September 25, 2020

David Albright
Manager
Groundwater Protection Section, Water Division,
EPA Region 9
75 Hawthorne Street
San Francisco, CA 94105

Re: Panoche Energy Center, LLC comments on UIC Permit No. R9UIC-CA1-FY17-2R

Figure 1

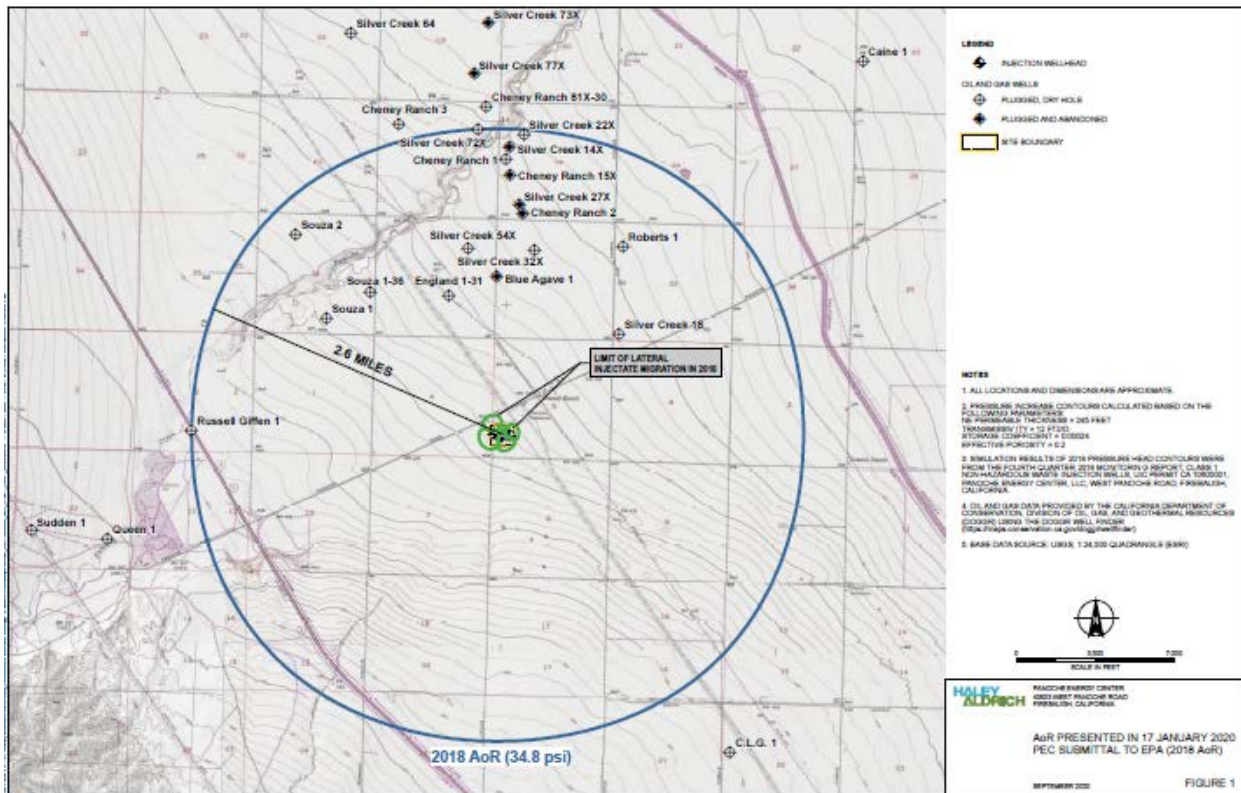
Step 4. The modeled distribution of a 34.8 psi increase in injection reservoir pressure was geographically rendered in Figure 1.

Figure 3

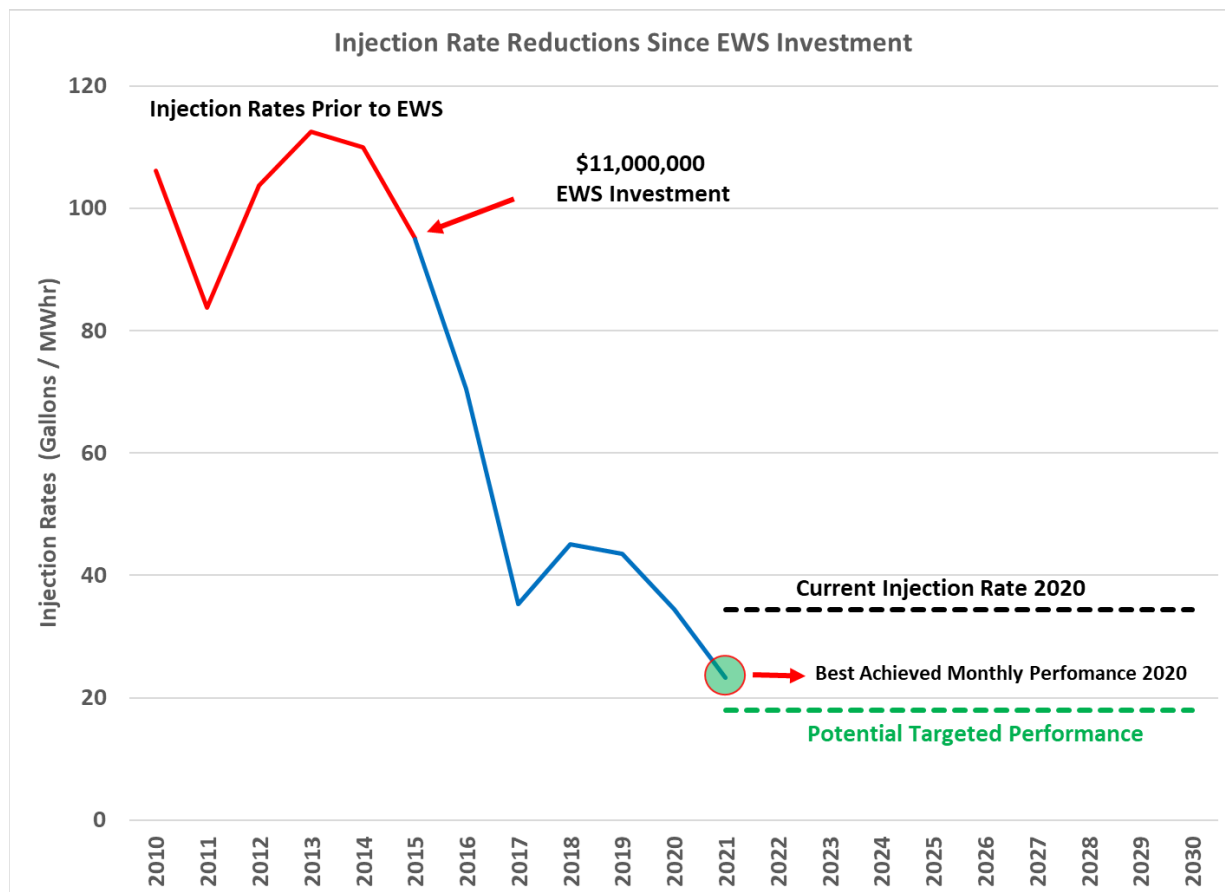
PEC's September 2020 Analysis for the EWS and reduced injection volumes (Figure 2) shows that the mud column hydrostatic pressures in Souza #2, Silver Creek #18 and England #1-31 (Figures 3, 4, and 5, respectively) have always been in excess of the maximum reservoir entry pressures. In addition, the EWS evaluation also shows that each well experienced its highest increase in reservoir pressure in 2017; and since then, induced pressure within the reservoir has and will continue to decrease, due to lower injection volumes, throughout the life of the permit. These improvements are a direct result of the EWS commissioning in 2016.

The hydrostatic pressures shown in Figures 3, 4, and 5 below represent the forces exerted on the injection reservoir from the mud weight in Souza #2, Silver Creek #18 and England #1-31 for the September 2020 Analysis compared to the modeled injection zone reservoir pressures.

Souza #2 Pressure History and Expected Future Pressure Decreases

The reservoir pressure at Souza #2 has never exceeded the hydrostatic pressure in the well.

Figure 6

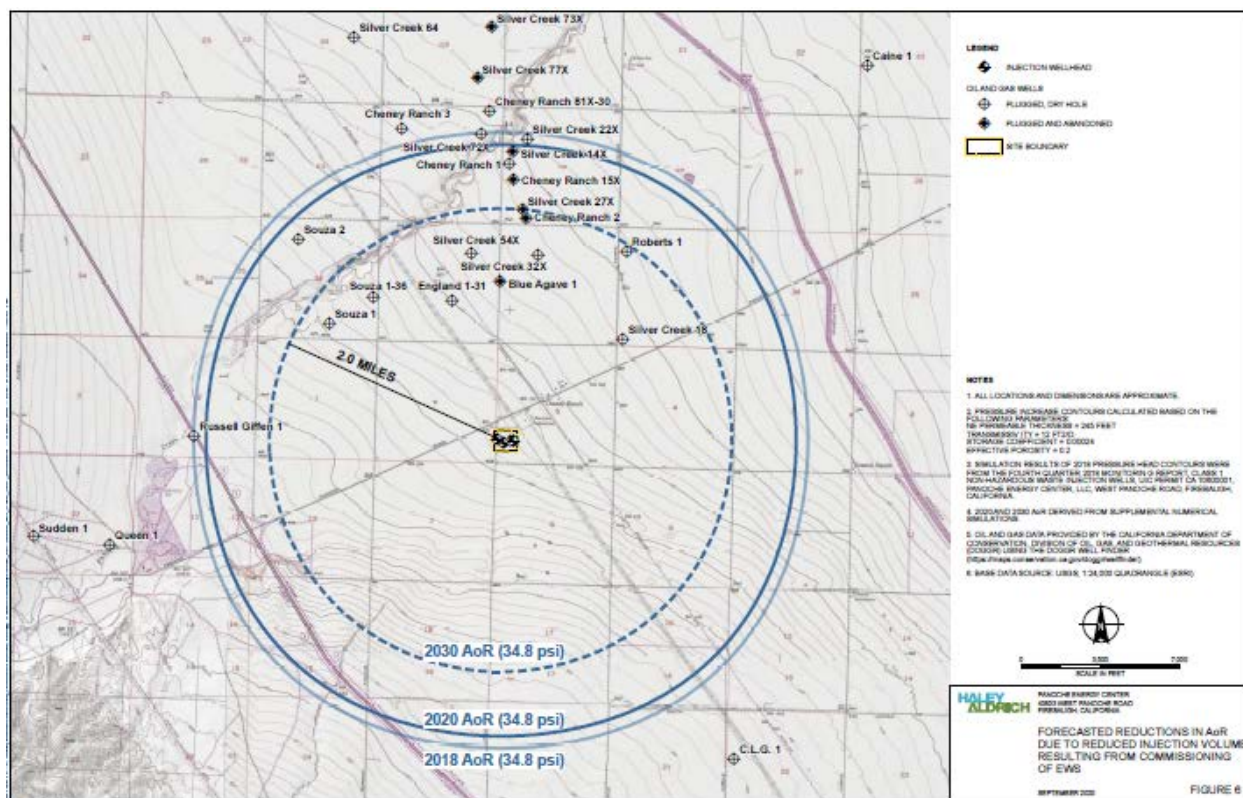
In addition, PEC has modeled how the EWS will reduce the AoR as a function of reduced injection volume over the life of the permit. As shown Figure 6 below, the AoR has contracted from 2018 to August 2020, and will continue to contract inward significantly by 2030.
